NORTH CORE - MEZZANINE FLOOR - LIFT LOBBY - PART 1 STONE LAYOUT - 1:20

HG Drawing No.: C5527-HG-N201

Project	Centre Point London		
Drawing Title	Stone Layout part 1 - Lift Lobby Mezzanine Floor - North Core		
Status: Construction	Date: 20/10/2016	Scale: 1:20@A1	
Job No.: 658	Drawn by: MKS	Checked: MG	
Origin	CISFB	Building Code	Level
H1312	21	CPT	M
Code		Series	Revision
		100	03

Movement Joint detail

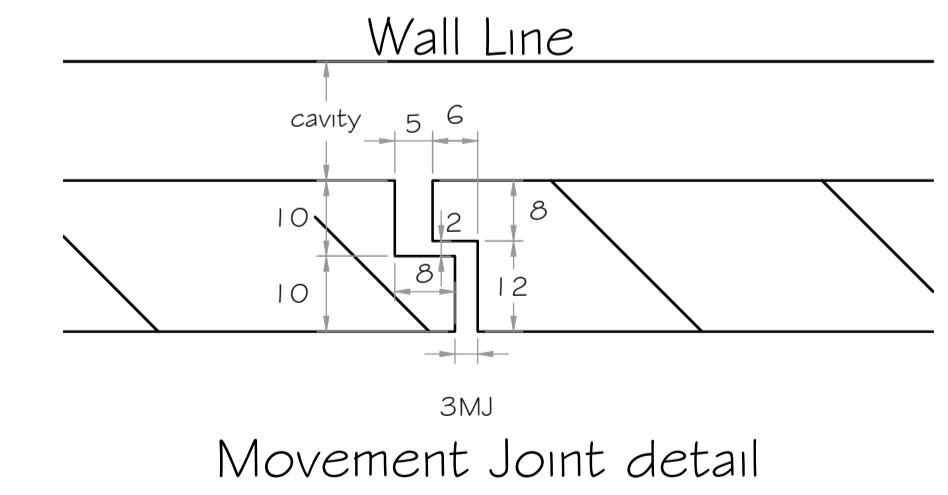
Paye Note:
- coordinate panel & fixing with services.
- Sprinkler routes to be coordinated with Architect Note 13/04/2017:
- Info from LS required to coordinate M+E including the side wall sprinkler routes.
